[Docket No. NHTSA–2013–0097]

Federal Motor Vehicle Safety Standards; Ejection Mitigation

ACTION: Final rule; response to petitions for reconsideration.

Figure 1 – Effect of a Grab Handle on the Target Locations of a 1st Row Window

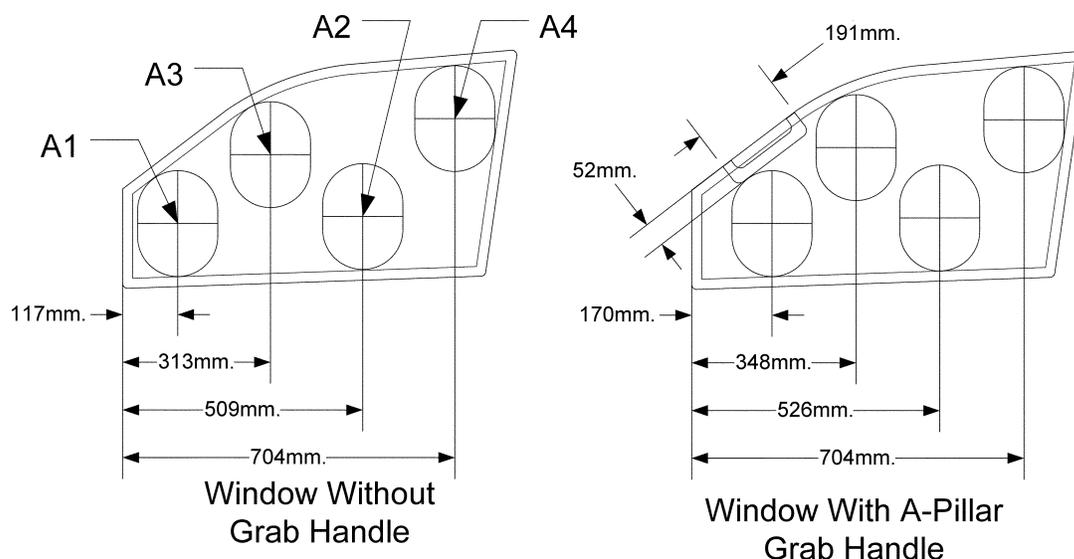
In its petition for reconsideration, the Alliance disagrees with the agency's decision in S6.3 to remove or adjust grab handles. The petitioner states that grab handles located inboard of the air bag deployment path are commonly attached through the headliner or A-pillar garnish trim to the vehicle structure. The petitioner states:

“Removing these handles can change the headliner and trim attachment structure and bending characteristics. Changing the bending characteristics of the headliner can lead to curtain airbags [sic] not deploying as

designed and there could be unintended interactions with the testing device.” The Alliance also states that, for handles located outboard of the air bag deployment path, the grab handles may also function as a reaction surface for curtain air bags. “If the handles were to be removed, the deployment characteristics and reaction surface of the airbag [sic] would be changed from the design intent. In addition, the surface of the pillar would be changed, which could lead to exposed mounting brackets and rough surfaces that can lead to tearing of the airbag [sic] and/or a change of the deployment characteristics.”

Moreover, we are concerned that the requested amendment would create a means to manipulate the test requirements, to enable designers to move the impactor away from weak points in the ejection mitigation countermeasure in a false way. Figure 1, below, depicts two renditions of a 1st row daylight opening. The illustration on the left shows the opening without a grab handle; the other shows a grab handle attached to the A-pillar. For convenience, we used an approximation of the target outline, rather than the exact cubic equation prescribed in the final rule. The target outline height and width are dimensionally correct relative to each other.

Similarly, Targets A3 and A4 have an average displacement of 132 mm and 15 mm, respectively. Moving target A3 towards the A4 target (by 35 mm, in our example) would likely reduce the displacement of the impactor at the A3 location. Finally, the original A2 target is moved rearwards toward the B-pillar (by 17 mm, in our example). Decreasing the proximity to the B-pillar may add support to the curtain, which will tend to reduce the impactor displacement.

real world. For grab handles, we have determined there is reason to remove the component (and the other items listed in S6.3) due to potential interference with the impactor. However, we concur that the grab handle should be removed with minimal disturbance to the trim.

Figure 2 – Graphic provided by ASC, showing a daylight opening with no top right-hand corner

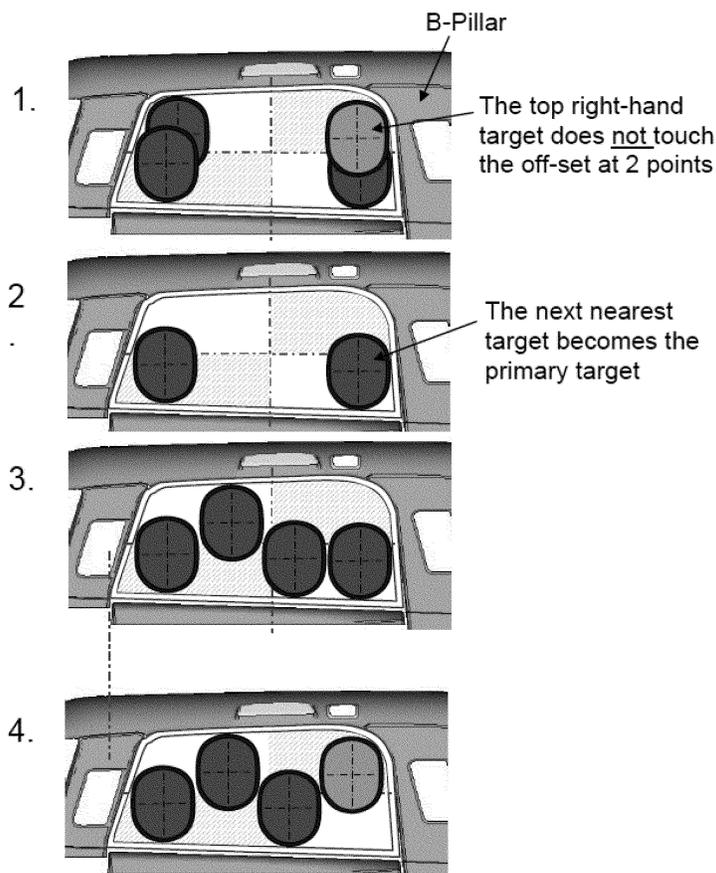
ASC asks for clarification of the targeting procedure for a window opening with a large radius, regarding the forward-upper quadrant of the daylight opening. It asks how NHTSA will position a target at the “corner” location(s) for this area of the window (top image (labeled “1”) in Figure 2, below.). ASC states that if the procedure is followed as written, the target would only contact the daylight opening offset-line at one point and, therefore, this quadrant would not contain a target. ASC states that S5.2.3.3 then specifies that the forward lower target would become the new primary target (image labeled “2” in Figure 2). ASC states that continuing with the specified test procedure, the selected targets would be as illustrated in the image labeled “3” in Figure 2. ASC believes that NHTSA intended the targets to appear as shown in the image labeled “4” rather than image 3 and asks for clarification of the procedure to achieve the target layout shown in image 4.

ASC is correct that the procedure of S5.2.3 results in the layout shown in image 3 in Figure 2. However, it was not our intent that the test procedure must specify placement of a target in the forward-upper quadrant of the window opening no matter the shape of the daylight opening. We believe that the absence of a corner in the forward-upper quadrant is not typical, so the final placement of the targets in the example shown is also not typical. NHTSA has not encountered a situation like this in any vehicle we tested.

Figure 3 (Figure “5a” in regulatory text)

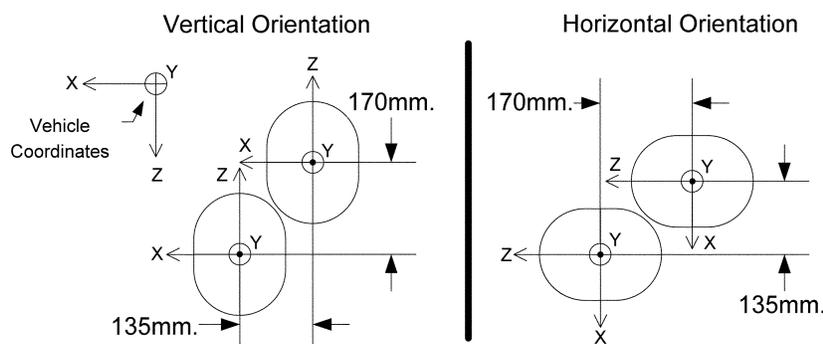
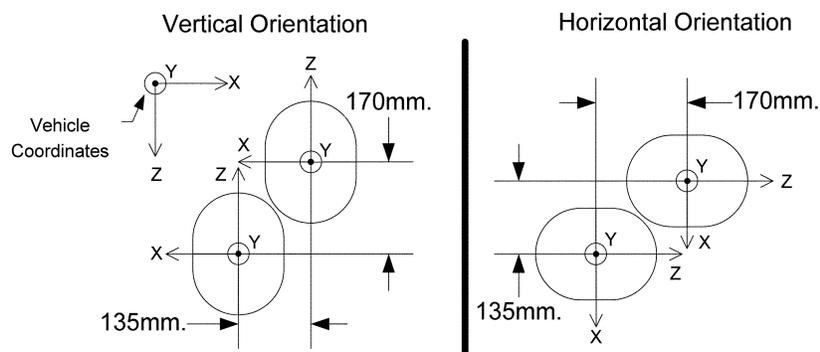
The Alliance believes that the reference coordinate axes used throughout the regulation, and particularly in S5.2, need illustrations and/or figures to better define the vehicle, headform and target axes, especially with rotation of the headform. TRW and ASC ask for clarification of S5.2.5.1.1 as to the specified distances between the target's local z-axis and x-axis, i.e., whether the distances remain constant irrespective of target orientation. Both the Alliance and ASC provide figures to illustrate their understanding of S5.2.5.1.1 and S5.2.5.2 and ask if their understanding is correct. They suggest that figures be added to the regulatory text to help clarify the relationship between vehicle and target axes when assessing possible target elimination.

We are granting this request. The figures submitted by the Alliance, TRW and ASC correctly interpret the regulatory text in S5.2.5.1.1. We agree that adding figures to the regulatory text would be helpful. We are adding the figures below to the regulatory text as new Figures 5a and 5b. Figure 3 below (new Figure 5a in the regulatory text) shows the vehicle and target coordinate systems from the perspective of a viewer facing the left side of the vehicle exterior. The minimum distance of 170 mm and 135 mm between the x and z axes, respectively, are also shown. The left side of the figure shows these minimum distances for vertically-oriented targets and the right side of the figure shows these for horizontally-oriented targets. Additionally, the right side of the figure provides the orientation of the z axis of the target specified in S5.2.5.2.

Figure 4 below (new Figure 5b in the regulatory text) shows the vehicle and target coordinate systems from the perspective of a viewer facing the right side of the vehicle exterior.

A reference to these new figures will be made in S5.2.5.1.1 and S5.2.5.2. Also, a typographical error is corrected in S5.2.5.1.1. The Alliance has noted that in the fourth sentence of S5.2.5.1.1, “y axis” is incorrectly referenced. The correct reference is “x axis.”

Figure 6 – Maximum overlap of targets under various scenarios

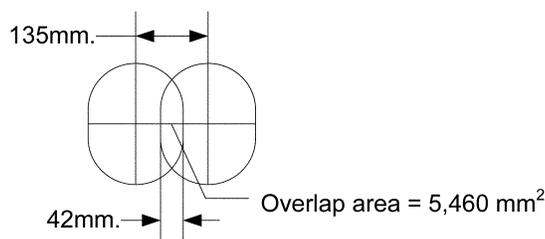
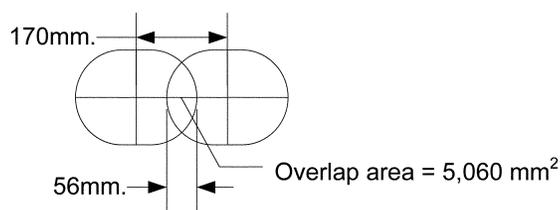
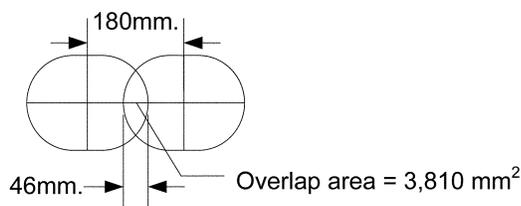
Example 3 is the situation for which ASC suggests the agency should make some form of accommodation to reduce the potential overlap. However, we see that, when compared to Examples 1 and 2, Example 3 has a smaller area of overlap than Examples 1 or 2 and less linear overlap than Example 2. The maximum potential overlap under S5.2.5.1.2 for horizontal targets is, in fact, less than the maximum potential target overlap for other target configurations. All-in-all, we do not believe that these targeting scenarios allow for excessive overlap. The targeting procedures ensure that the ejection mitigation countermeasure is evaluated throughout coverage of the daylight opening. Accordingly, because we do not believe the overlap allowed for horizontal targets by S5.2.5.1.2 is excessive, we see no reason to limit it further.

We decline to increase the 360 mm distance for horizontally-oriented targets.³² There is a potential for three horizontal targets to represent the final target locations under provisions of S5.2.5.2. The question presented is whether the overlap of the horizontal targets is excessive compared to the overlap “permitted” by the standard for vertical targeting configurations. To help in this assessment we have constructed Figure 6, below. This figure shows the maximum allowable overlap of targets under three different scenarios.

Figure 7
(Showing Figure 16 in NPRM)

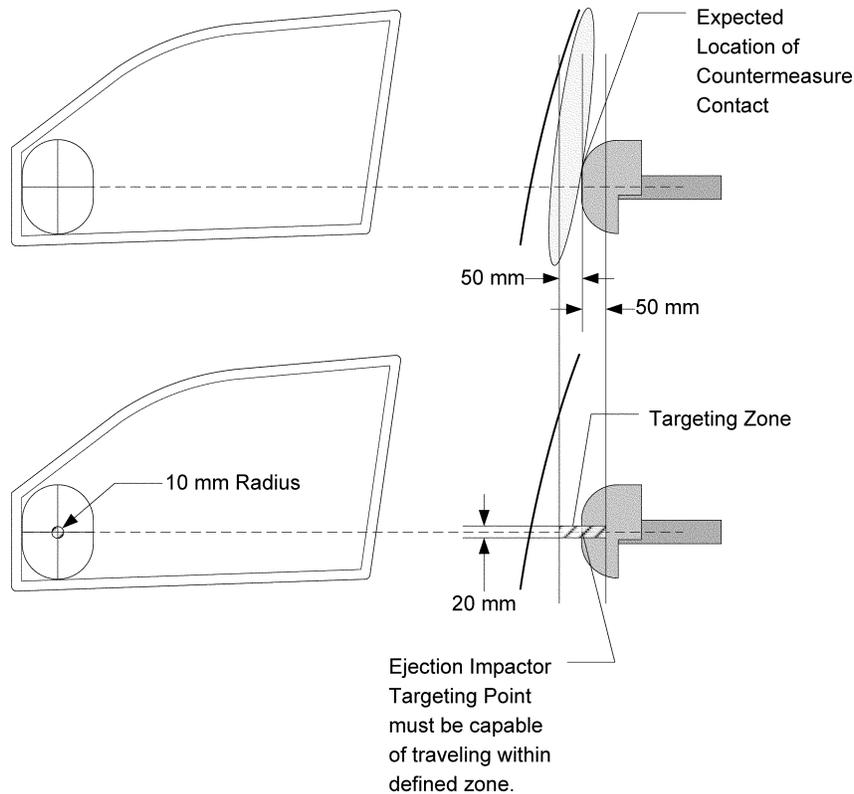
As shown in Figure 16, a zone could be established by first determining the “ejection impactor targeting point,” the intersection of the x- and y-axes on the outer surface of the headform. Next, the location of first contact between the impactor and the ejection mitigation countermeasure (e.g., ejection mitigation air bag curtain) would be determined, based on the location of the target outlines using the methodology in the compliance test specified for identifying the target outlines. A 100 mm wide zone would be determined by defining two vertical longitudinal planes that are 50 mm on either side of the expected location of contact by the impactor with the countermeasure. These longitudinal planes define a portion of the strike zone. The other portion of the zone would be defined by locating the axis normal to and passing through the target outline center. As the impactor targeting point passes at test speed through the 100 mm wide zone (as it passes “over the plate,” using the baseball analogy), it must stay within ± 10 mm of the axis passing through the center of the target outline center (continuing the analogy, it must stay within the vertical zone bounded by the batter’s knees and chest). This assessment would not be conducted with an ejection mitigation air bag curtain

We are granting the request to revise S7.4. The Alliance is correct that the zone specified in S7.4 is a cylinder with a 10 mm radius. However, “D” does not represent the line segment that the cylinder is centered around. Rather, “D” was intended to be a point of reference for the theoretical point of contact with the countermeasure. In response to the Alliance’s comment that vertical and longitudinal planes cannot be defined in vehicle coordinates as forward and rearward of a lateral segment, the terms

After reading the Alliance’s petition, we have revised S7.4 solely for purposes of clarifying it. No substantive change is intended. Among other things, we have rewritten S7.4 to indicate the cylindrical nature of the zone of interest and to eliminate the reference to distance “D,” since the reference to D was confusing to the petitioner.
